**RE: Nusenda Credit Union
6401 Uptown Blvd NE
Grading and Drainage Plans
Engineer's Stamp Date: 1/5/26
Hydrology File: H18D012
Case # HYDR-2026-00001**

Based upon the information provided in your submittal received 01/05/2026, the Grading & Drainage Plan **is not** approved for Building Permit. The following comments need to be addressed for approval of the above referenced project:

1 | grading and drainage plan
 C101 | 1"=20'-0"

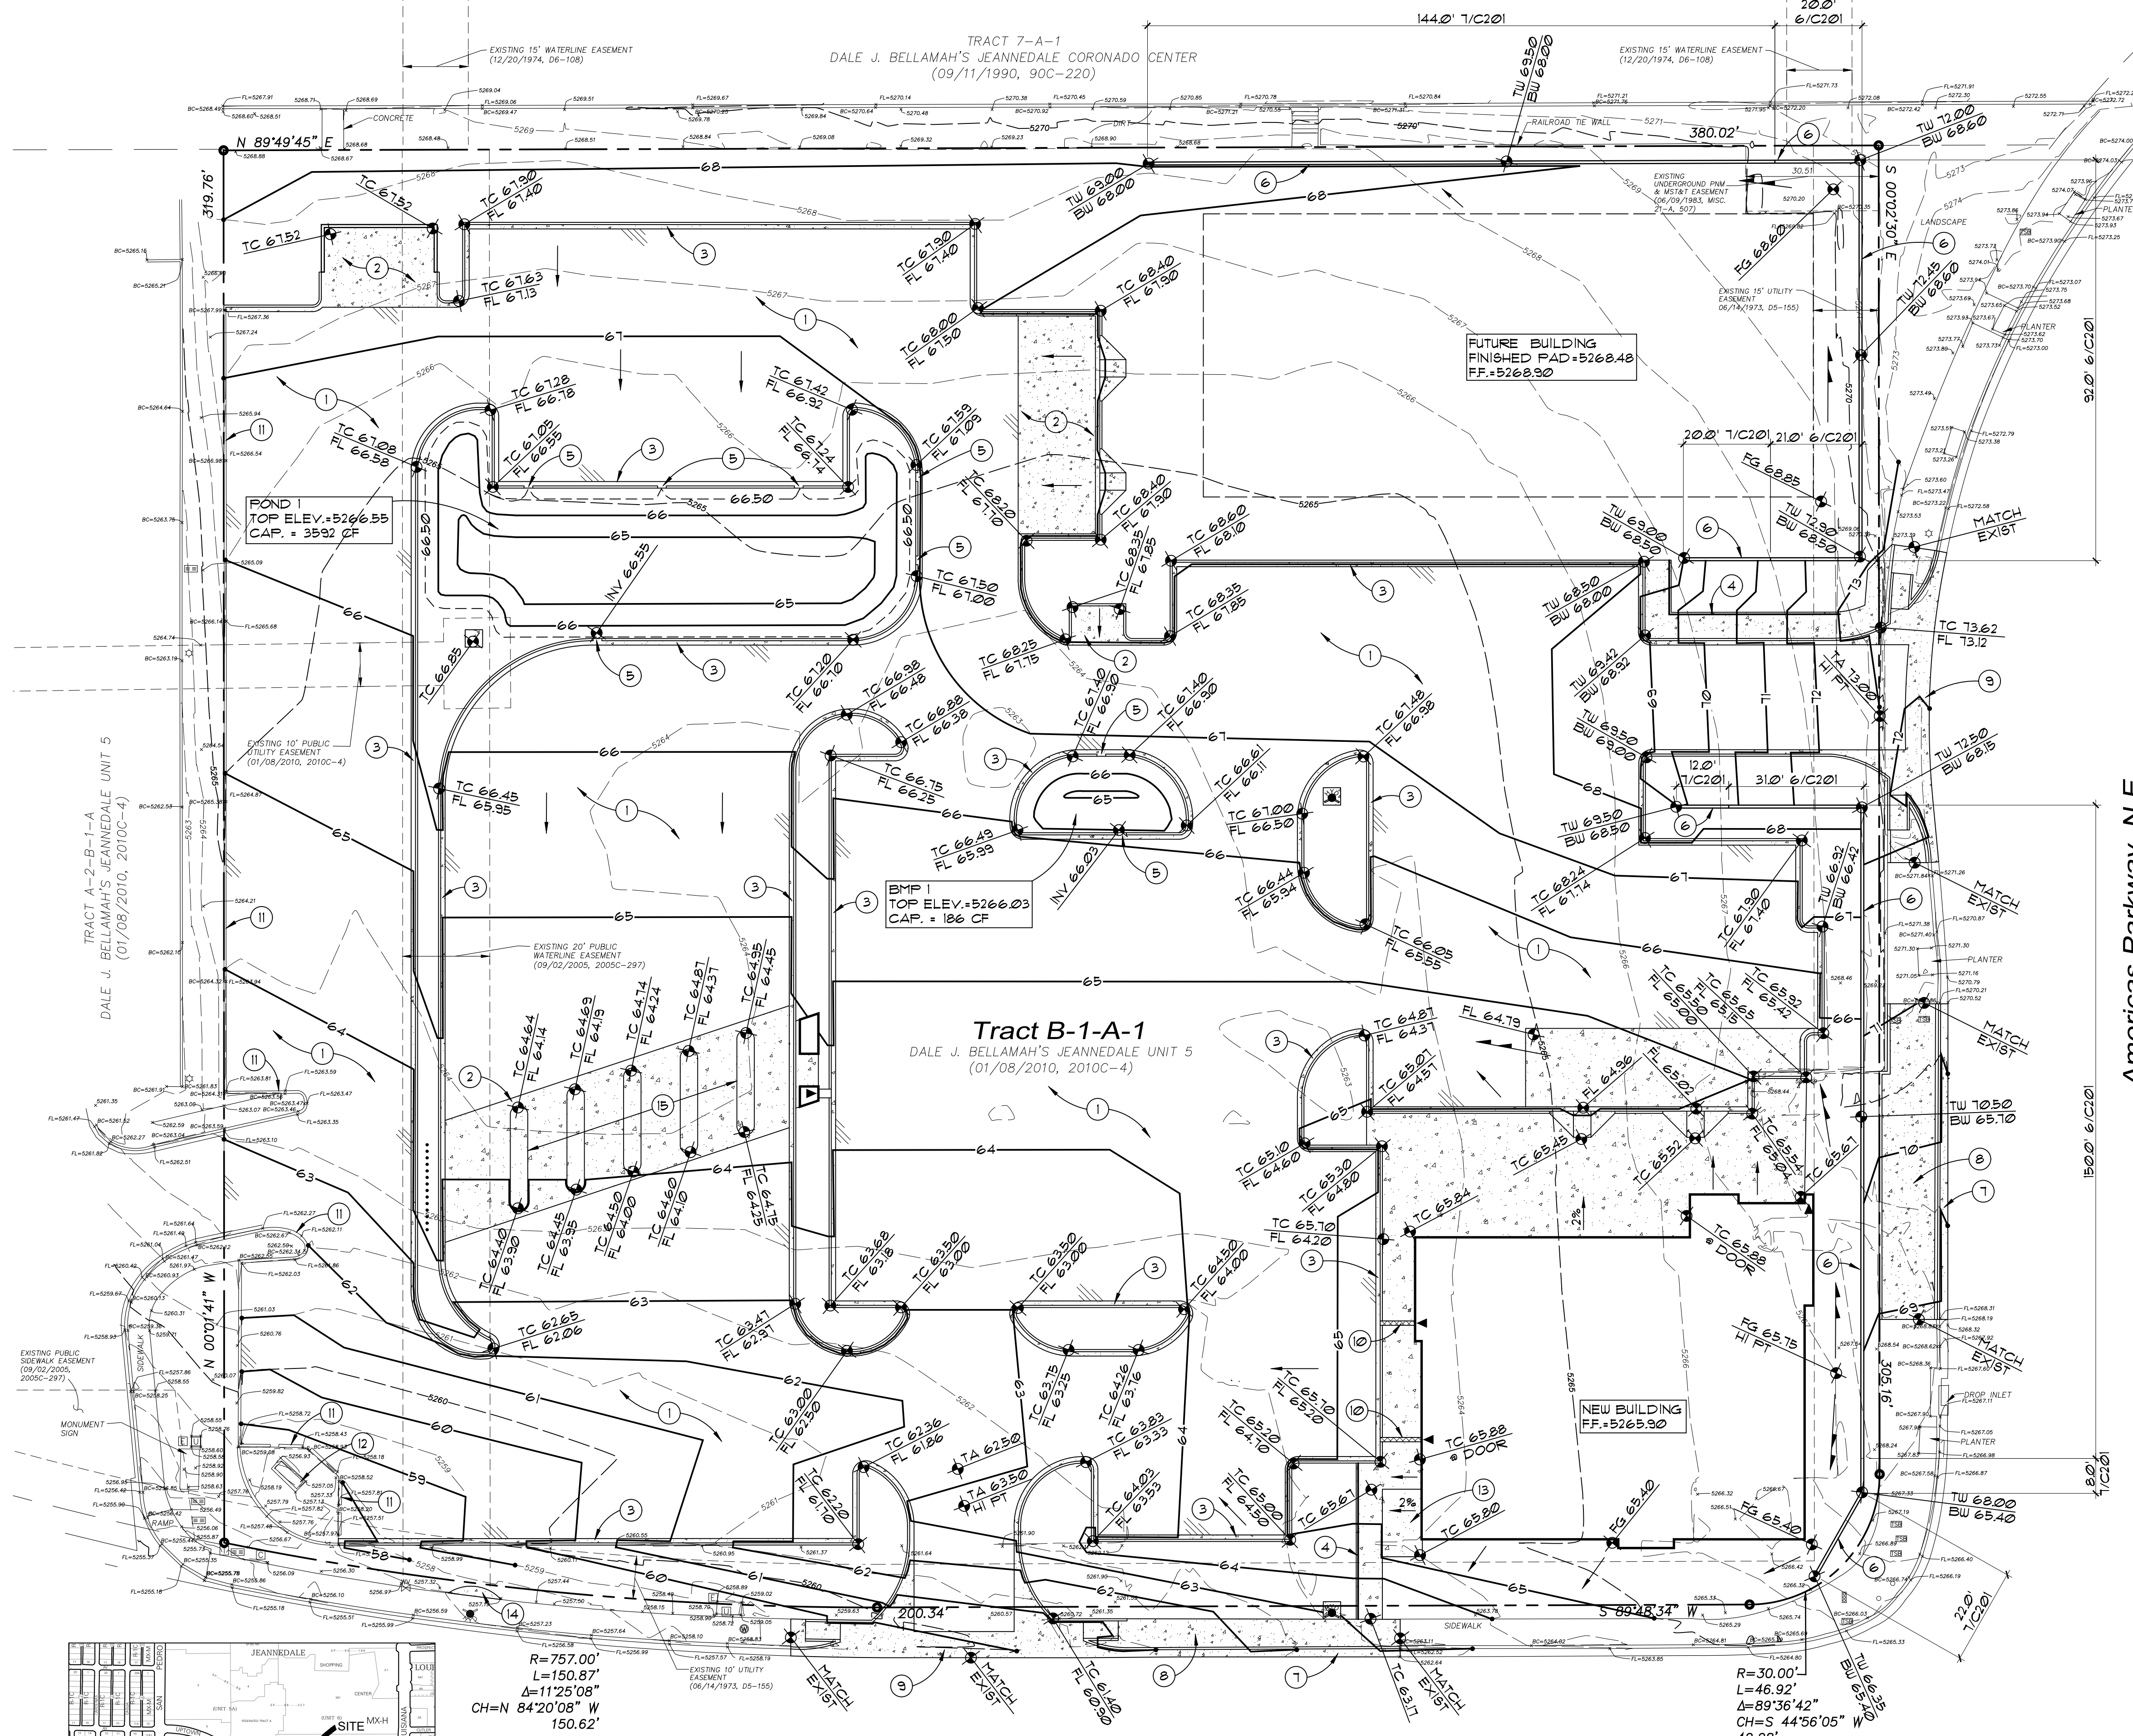
1. Please provide the FIRM Map and floodplain note with effective date.
